Historic Architectural Review Board

A G E N D A

Thursday, February 21, 2019 1:00 p.m. *Amended
Alcazar Room - City Hall, 75 King Street, St Augustine, Florida

FIRST FLOOR PLAN (REVISED)

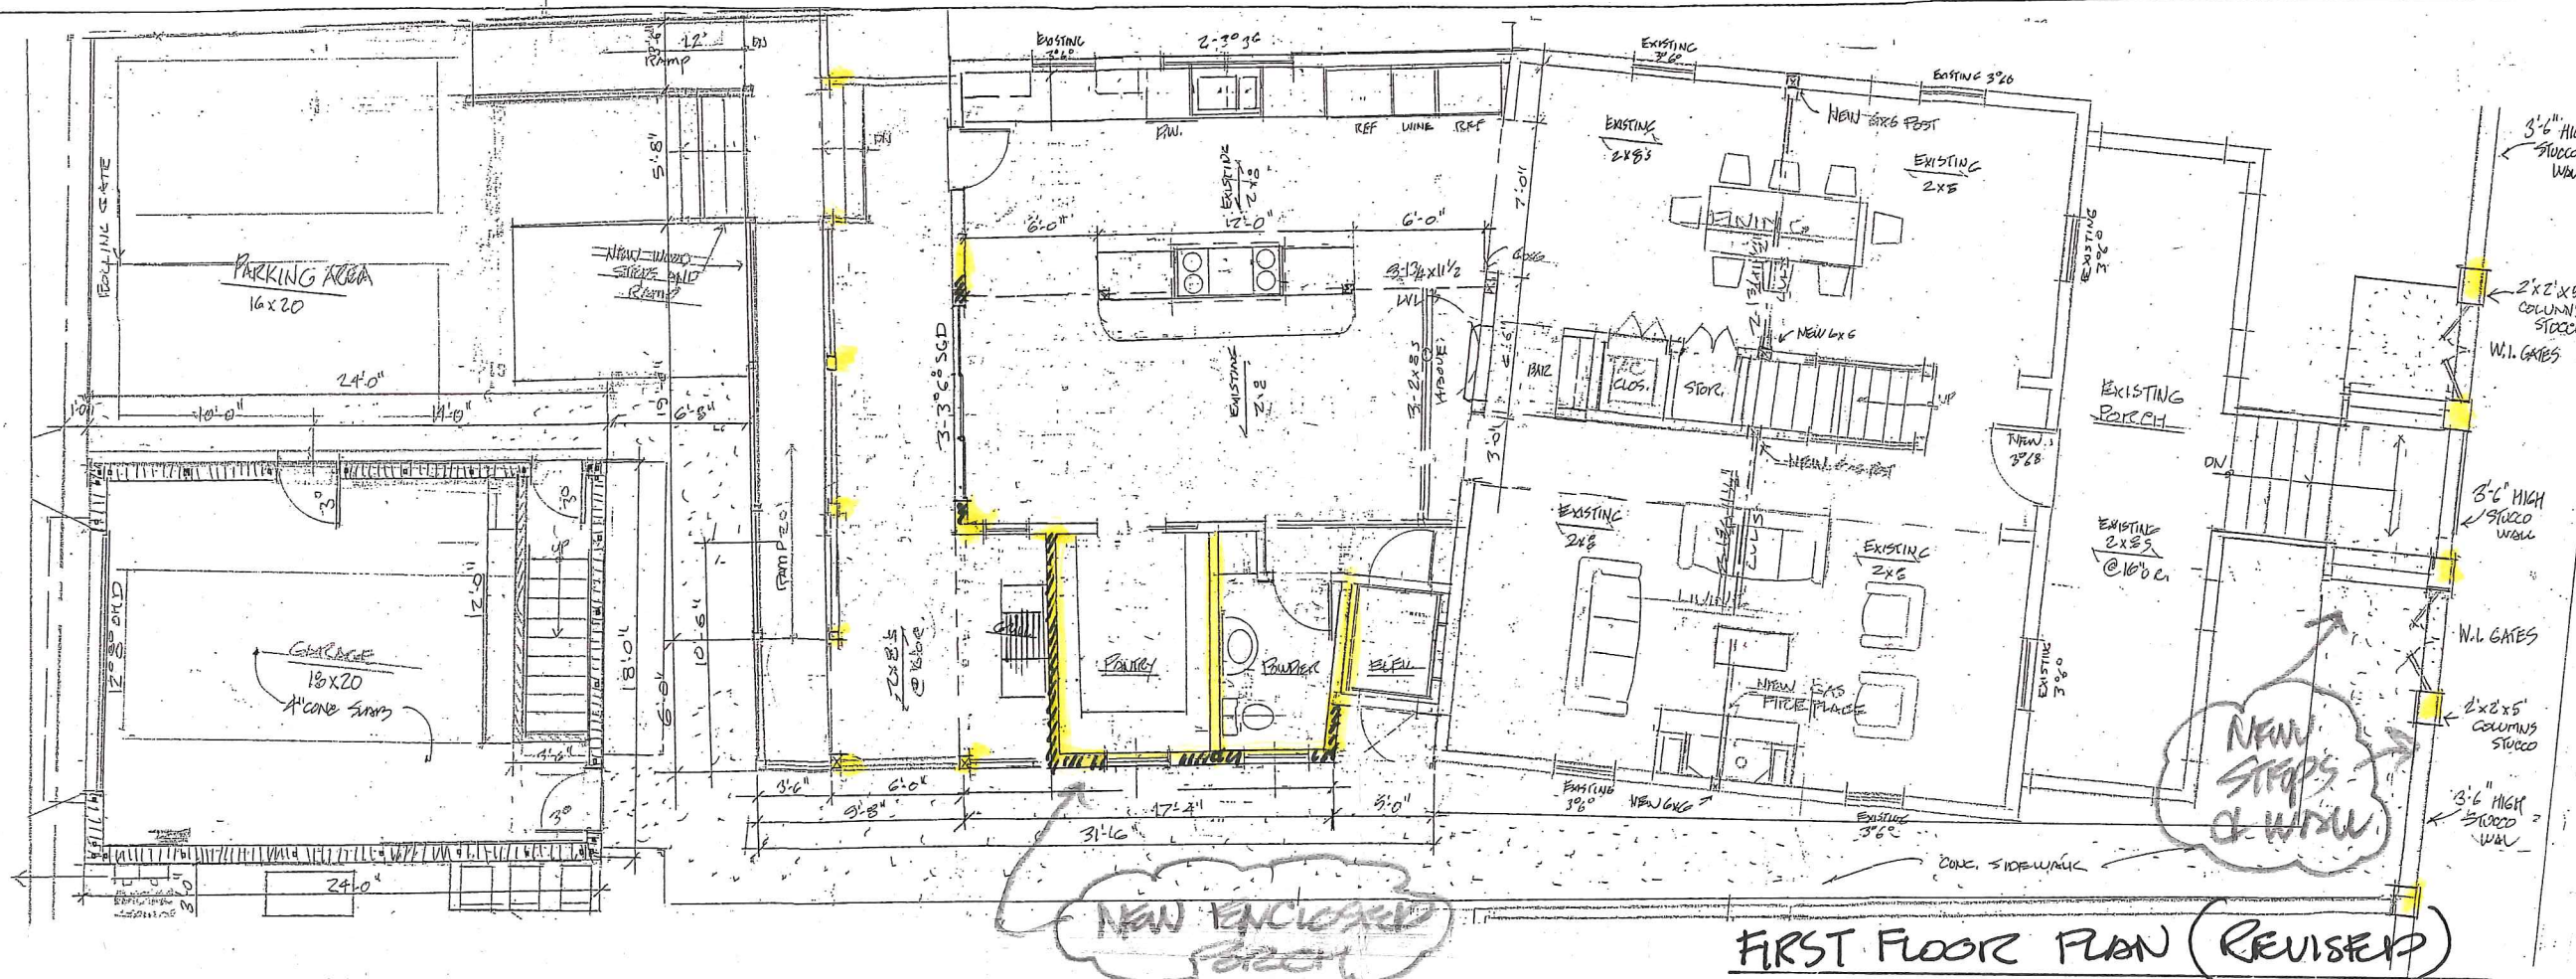
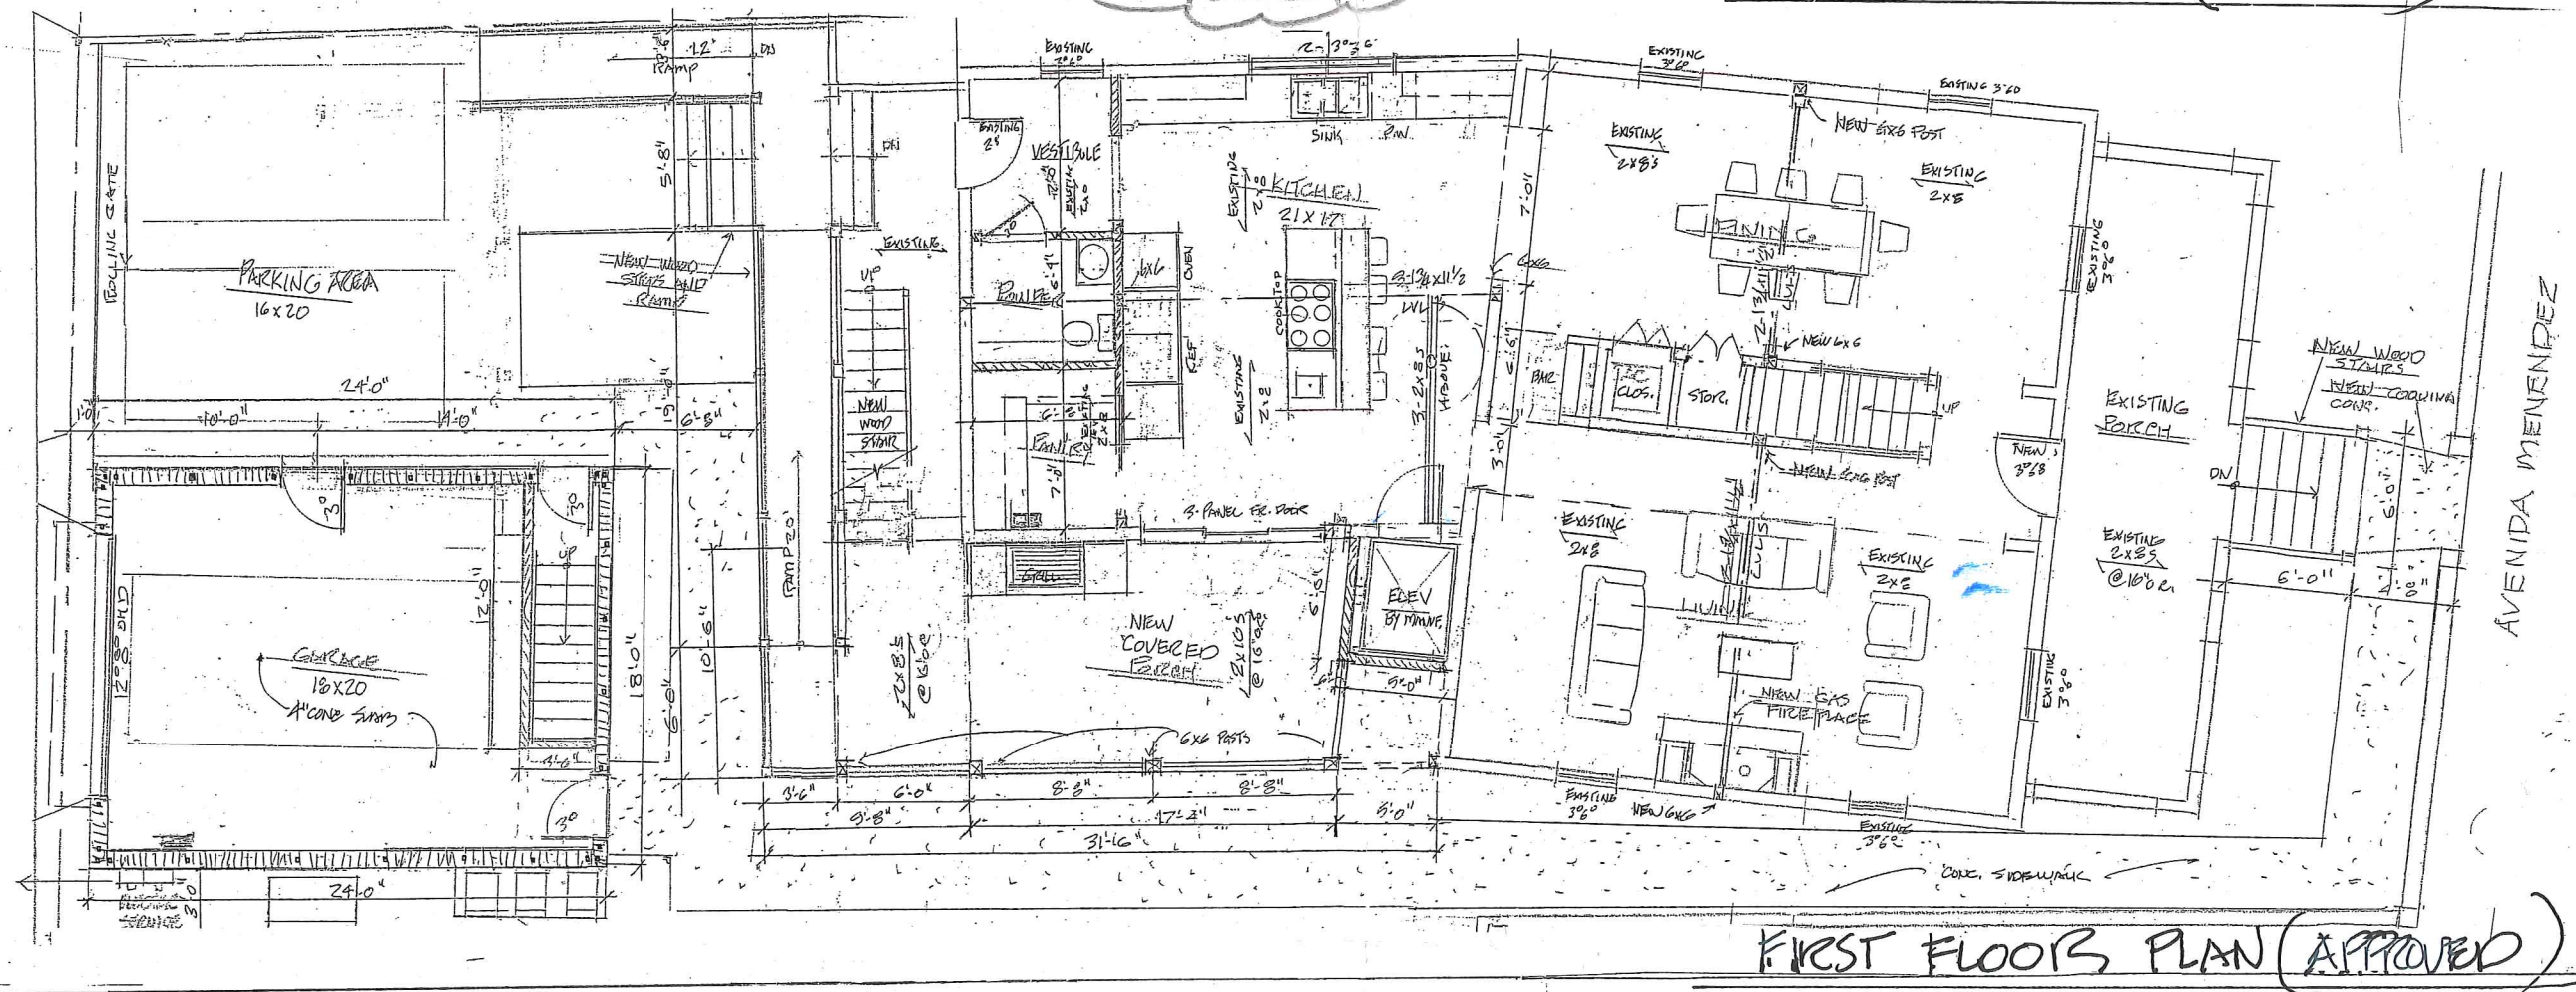
- a) Certificate of Appropriateness 2019-0005
Les Thomas Architect, Inc. – Applicant
Scot and Susan Bebry – Owner
[57 Marine Street](#) (a.k.a 154 Avenida Menendez)
To make alterations to an existing Certificate of Appropriateness to include enclosing a section of the proposed first story rear porch, altering the proposed front staircase and the front wall, adding new windows, and removing the stairs leading to the second story porch.

- Alter approved front staircase to include adding a single landing two minor stairs that are perpendicular to the straight staircase
- Alter the existing knee wall and add new openings to accommodate the proposed stairs
- Enclose a section of the proposed side porch and add two six-over-six windows
- Add a new window on the first floor back porch
- Remove staircase connecting the first floor back porch with the second story porch

SITE PLANS

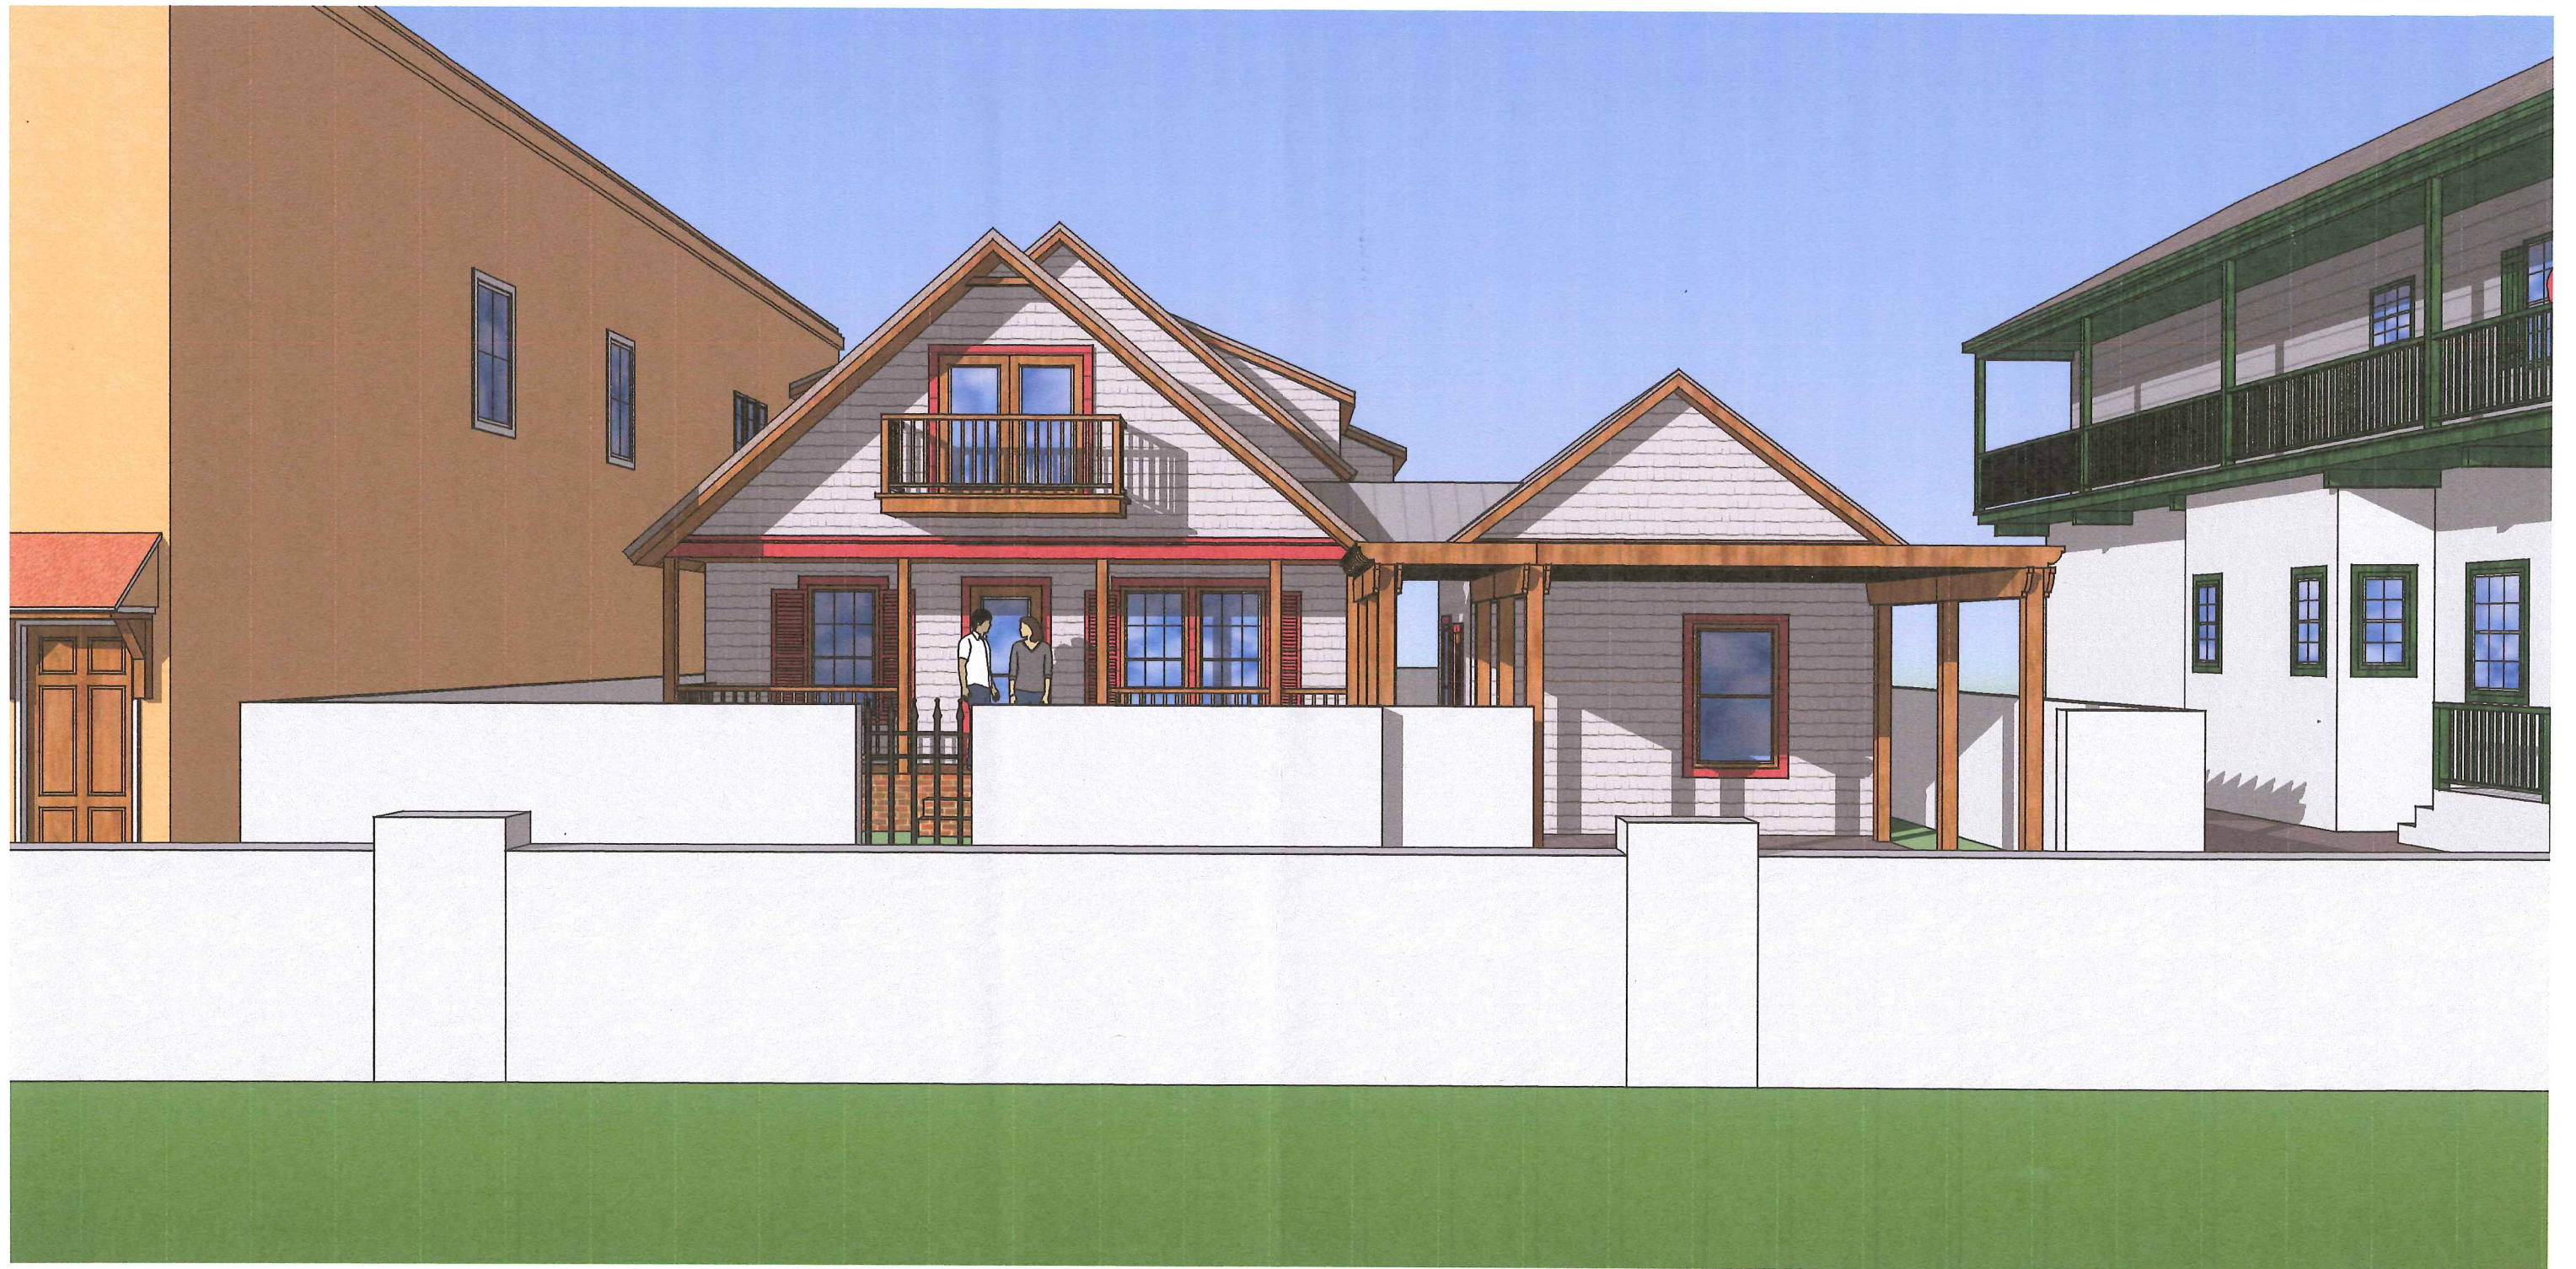
- The applicant made some modifications to respond to HARB's comments to include lowering the dormers, reducing the height of the stairwell, reducing the height of the side addition/accessory building from two stories to one story, and moving the pergola in front of the one story structure.

- The applicant should consider reducing the size of the pergola to allow it to have a more residential scale and should center or add a second window on the eastern elevation of the one-story building.

1. HARB finds that the alterations conform with the AGHP and with the Secretary of the Interior Standards for Rehabilitation.
2. The pergola is reduced in size to fit a residential scale.
3. The window on the eastern elevation of the secondary structure is centered or a second window is added.
